- 19 [PR-CM] Development Application DA10/0222.26 for an Amendment to Development Consent DA10/0222 for Casuarina Town Centre Including 56 Lot Subdivision, Road Works, Infrastructure Works and Landscaping (Department of Planning Application MP06\_0258) MOD 10 a

This is the second report which has been brought to Council on MOD 10 to MP06\_0258 in regard to the Casuarina Town Centre (Council Reference DA10/0222.26). The first report was from 21 April 2016 in which concerns were raised with various elements of the proposed modifications (see attachment). Since this time the applicant has responded positively to Council's concerns and has invested a significant amount of time and resources into amending the proposal to address the matters raised.

The purpose of this report is to identify the changes that have been made since the original report and seek formal land owners consent from Council for the works within the "yellow" community land to the east of the town centre site shown below which is mapped as "community land".

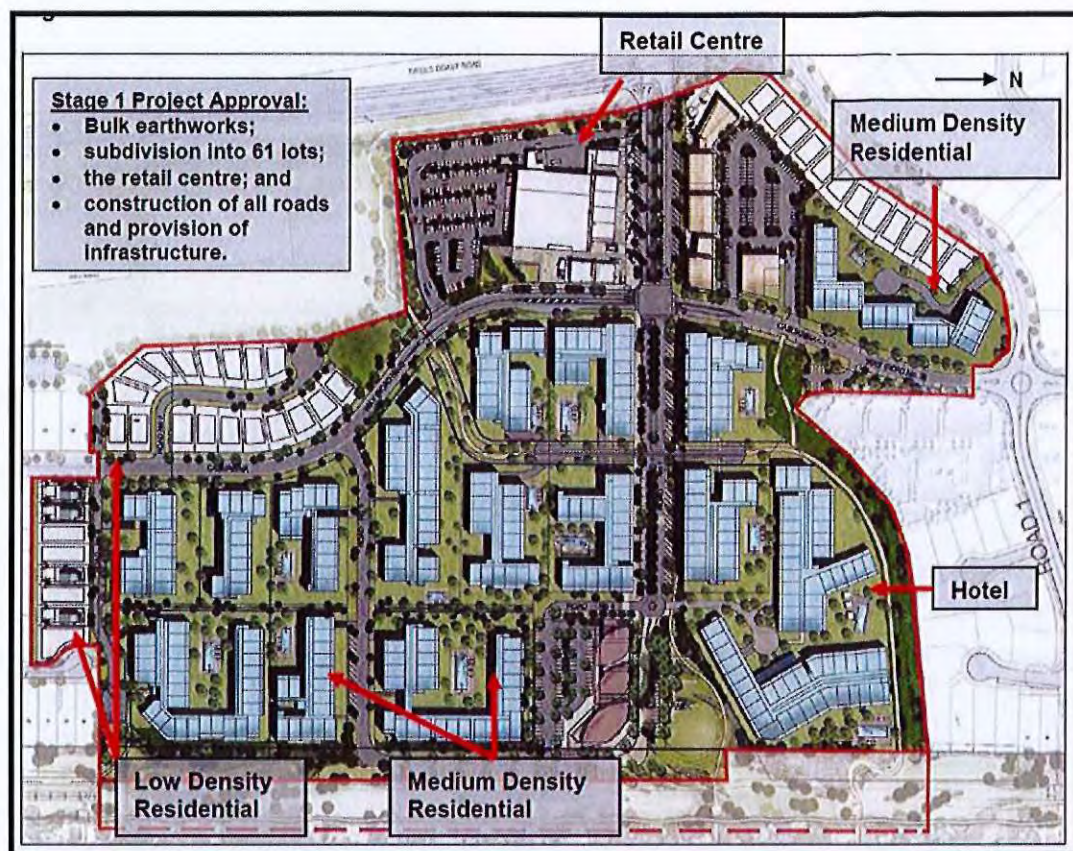
<p>ii. The proposal seeks to defer the approval for the beach access from prior to the release of Stage 1C to the Construction Certificate for the Icon Building in Stage 2.</p>	
Treatment of the Northern Drainage Swale	<p>i. Stormwater management proposed for the site seeks to substitute a major stormwater pipe network in lieu for the existing deep swale that traverses the site. In addition, the development shall provide the same quantum of infiltration areas as previously nominated in past approval documentation submitted by Cardno (2008).</p> <p>ii. The subdivision layout was modified to incorporate a local road within the 20m northern buffer.</p>	<p>i. The proposed filling of the swale is retained. The stormwater management plan has been amended pursuant to the Stormwater Management Plan (dated May 2017) and designs prepared by BG&amp;E as attached to this letter.</p> <p>ii. The subdivision layout has been modified to re-position the local road and residential lots outside the 20m northern buffer as illustrated in BG&amp;E Drawing C-0003 (Rev D)</p>

Modified lot layout & built form density	<p>i. The newly designed road layout lodged with Mod 10 responds to the amended lot layout.</p> <p>ii. Modify the building height to accord with the prescribed maximum building height under the Tweed LEP 2014.</p> <p>iii. Removal of the tourist hotel.</p>	<p>i. Increase the number of lots by a single lot to 93 Lots (inclusive of 2 public reserves).</p> <p>ii. No modification to the building height is proposed to that originally sought in Mod 10 and therefore continues to accord with the Tweed LEP 2014.</p> <p>iii. The tourist hotel is still sought to be deleted consistent to the originally lodged Modification.</p>
Site Filling	<p>Utilisation of excess fill within the balance of Stage 2;</p>	<p>No amendment to the planned filling as originally lodged is proposed.</p> <p>Reference is however made to the proposed earthworks and the interface with the coastal reserve. In this respect, the placement of retaining walls within the reserve has been removed from the proposal. The amended design now provides for the proposed retaining walls to be relocated onto private land for Lots 85-91. The land forming for the eastern infiltration basin is therefore deemed to be superior to the previous design and will create a useable/manageable landform within the coastal reserve.</p>

Project Approval	Obtain Project Approval to create 92 lots over the balance of the Casuarina Town Centre for future single dwellings, mixed use development and residential flat buildings	An additional residential lot has been included in the lot layout. Accordingly, the proposal has been modified so as to obtain Project Approval to create 93 lots over the balance of the Casuarina Town Centre for future single dwellings, mixed use development and residential flat buildings
Road & Pedestrian Access Design	<ul style="list-style-type: none"> <li>i. No roundabouts proposed at 4-way intersections.</li> <li>ii. The proposed modification sought to reduce the proposed cycleway within the northern buffer from 3.5m to 2.5m width</li> </ul>	<ul style="list-style-type: none"> <li>i. Roundabouts introduced to 4-way intersections.</li> <li>ii. The proposed modification has been amended to provide the pedestrian/cycleway at a 3.5m width.</li> </ul>

Sewer Design	<ul style="list-style-type: none"> <li>i. Conventional sewer design was proposed with a variation to the maximum sewer depth being sought in order to connect to existing infrastructure.</li> </ul>	<ul style="list-style-type: none"> <li>i. The current design provides for a combination of conventional gravity sewer and the inclusion of a sewer pump station. This approach addresses the depth of sewer infrastructure as faced with the originally lodged Modification.</li> </ul>

#### NEIGHBOURHOOD PARK

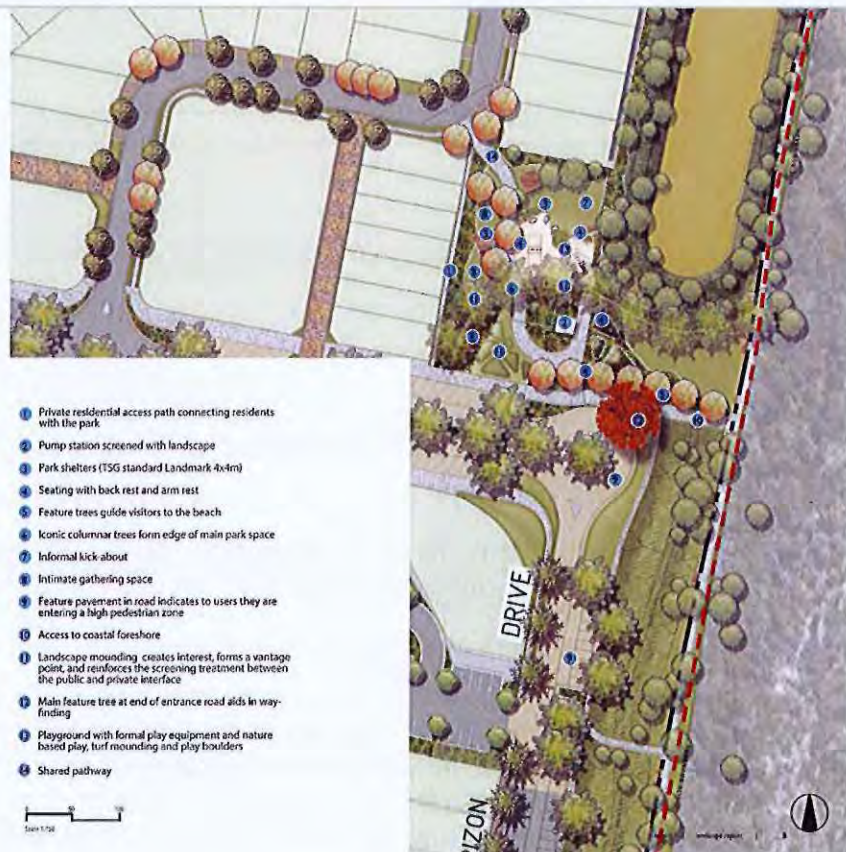
- Direct access into council parks from private allotments is not encouraged so pathways as shown are to be removed but some planting separation is acceptable as long as the garden beds are a minimum 1500mm off the property boundary to prevent canopy overhang issues in the future. It is also recommended to include breaks in the garden beds otherwise residents will simply walk through the garden beds;
- Any landscaping mounds must not be of a height that impacts on passive surveillance or CPTED principles;
- Now that vehicular access to the sewer pump station is off the roundabout (this needs to be shown more clearly on the landscape plan) the shared pathway through the rest of the park should be reduced from 3500 wide to a more pedestrian friendly scale of 1800mm wide; and
- Beach access to remain as is.
